Safety E	Tesco Corporation
No: SB043 HXI Top Driv Accumulator		6204 – 6A Street SE Calgary, AB. T2H 2B7 Phone: (403) 692 5700 www.tescocorp.com

Figure 1 – Location of elevator link eye contact.

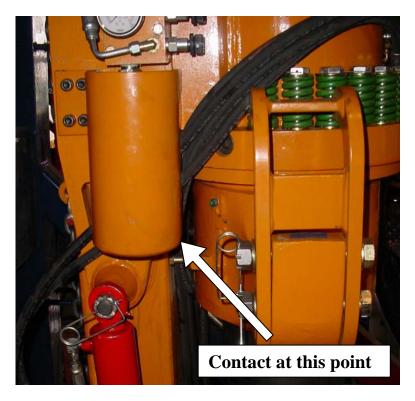
A potential mechanical interference risk has been identified wherein the driller side upper elevator link eye is able to come into contact with the grabber lift accumulator guard. The area of contact is shown in Figure 1.

Due to the close proximity of the grabber lift accumulator with the elevator link eye there are several conditions that may lead to this interference including,

- Incorrectly positioned elevator link clamps allowing excessive tilting of the elevator links.
- The use of links with large eyes.
- Load collar geometry allowing elevator link to move in a radius greater than intended design.

It has been brought to TESCO's attention that a number of units have been modified in the field by removing a portion of the accumulator guard to accommodate the range of motion of the elevator link eyes. This practice can result in a serious safety risk as, in addition to providing protection to the accumulator, the guard also serves as a secondary retention mechanism to protect against dropped object incidents. In one instance the portion of guard removed was sufficient to allow the accumulator to fall through the guard and resulted in a dropped object incident.

To eliminate the potential for mechanical interference TESCO has relocated the grabber lift manifold and accumulator to a position above the elevator link retainers as shown in Figure 2. Further, a safety cable has been implemented as a positive secondary retention for the accumulator in its new location. TESCO

recommends that all HXI model top drives have the grabber lift manifold and accumulator retrofitted to this new location.

Relocation of grabber lift manifold and accumulator:

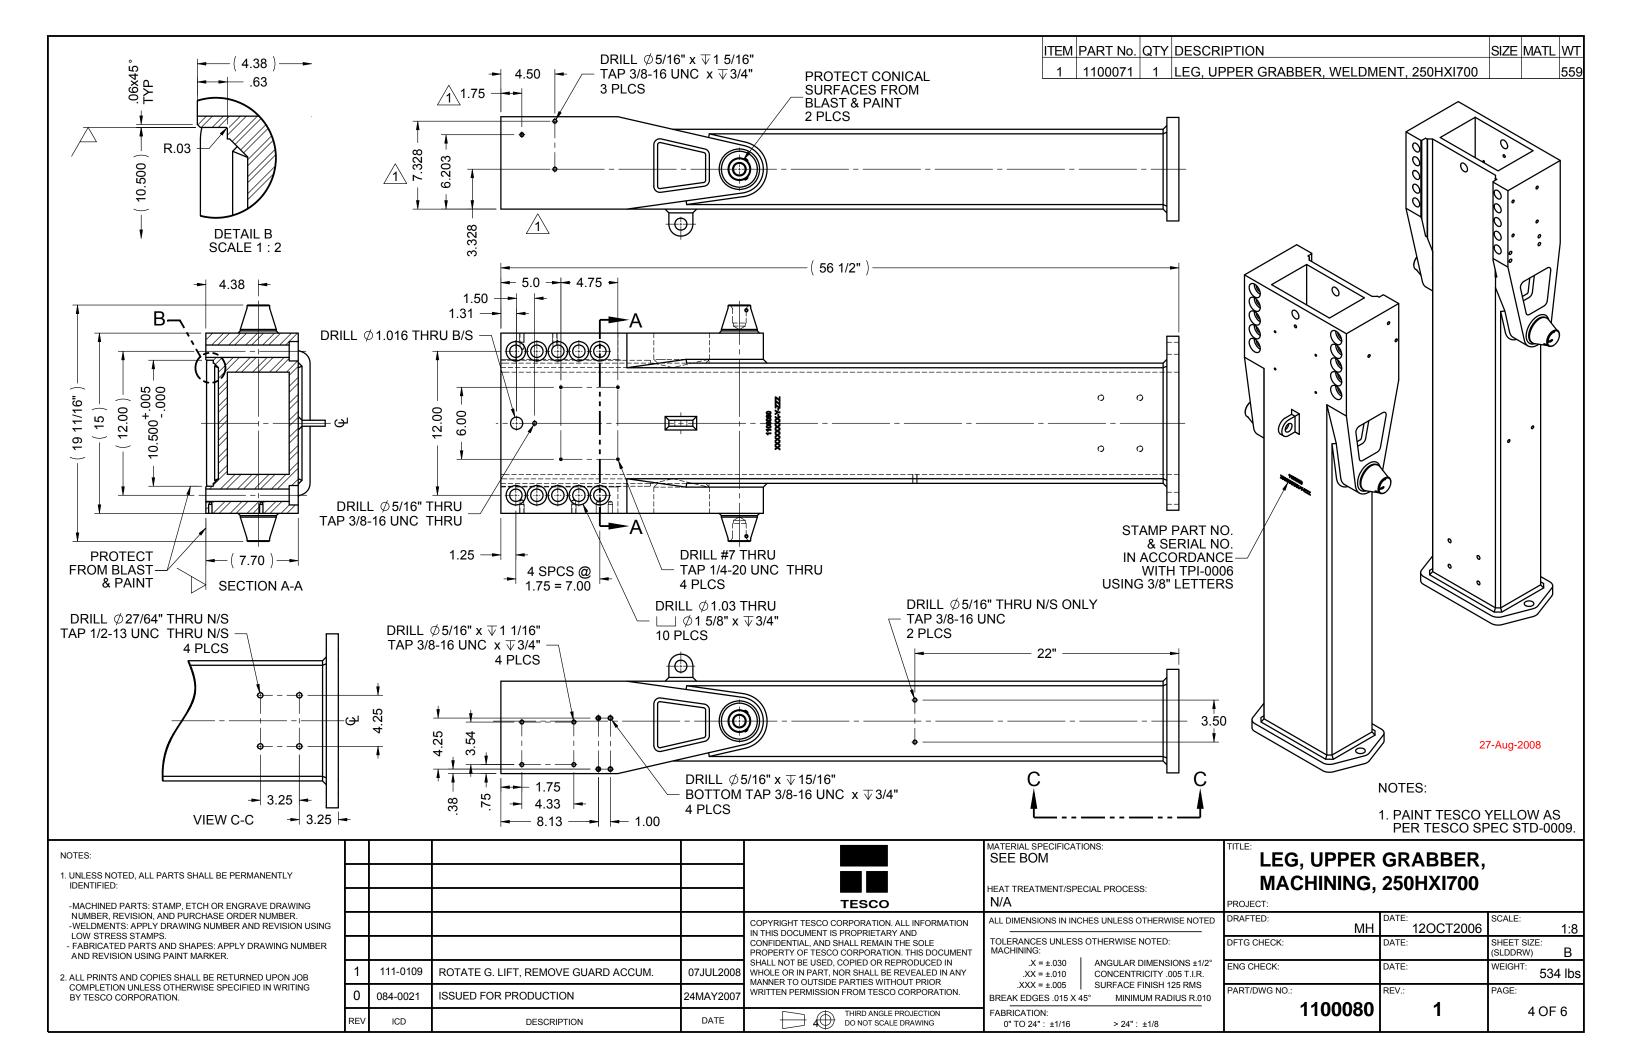
TESCO recommends that all affected units be inspected for signs of impact damage on the grabber lift accumulator guard immediately. Units that are showing signs of contact with the elevator link eye should be immediately retrofit to prevent future failure. If for some reason an immediate full repair is not possible, TESCO recommends, as a minimum, the addition of the safety cable to the accumulator until such time that the full repair can be made. Please contact your local TESCO representative who will perform the following repair.

- 1. Remove accumulator guard and manifold/accumulator assembly.
- 2. Layout locations for grabber lift manifold mount as shown in Drawing 1100080 Rev 1 (attached).
- 3. Drill and tap new manifold mounting holes in accordance with Drawing 1100080 Rev 1 (attached).
- Install clamp bracket and safety cable following instructions below and re-install grabber lift manifold/accumulator assembly in accordance with illustration I-1100047 Rev 5 or higher (attached).

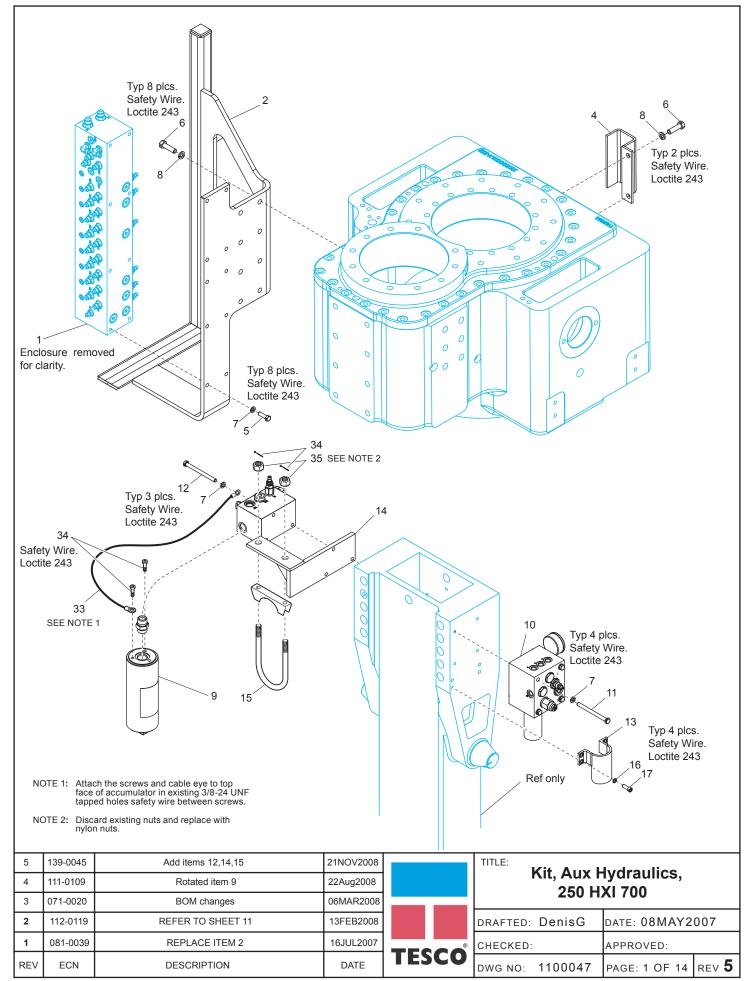
Addition of Clamp Bracket and Safety Cable:

- 1. Using 3/8"-24UNF x 1/2" fastener (TESCO PN 1390065), install safety cable (TESCO PN 1390064) onto accumulator as shown in Illustration I-1100047 Rev 5 or higher (attached).
- 2. Install accumulator clamp bracket (TESCO PN 1030251) between manifold and upper grabber leg as shown in Illustration I-1100047 Rev 5 or higher (attached).
- 3. Install accumulator clamp (TESCO PN 1030253) as shown in Illustration I-1100047 Rev 5 or higher (attached).
- 4. Using manifold mounting bolt, secure safety cable as shown in Illustration I-1100047 Rev 5 or higher (attached).
- 5. Ensure all hardware is installed using thread locking compound and is safety wired or retained with cotter pins as shown in I-1100047 Rev 5 or higher (attached).
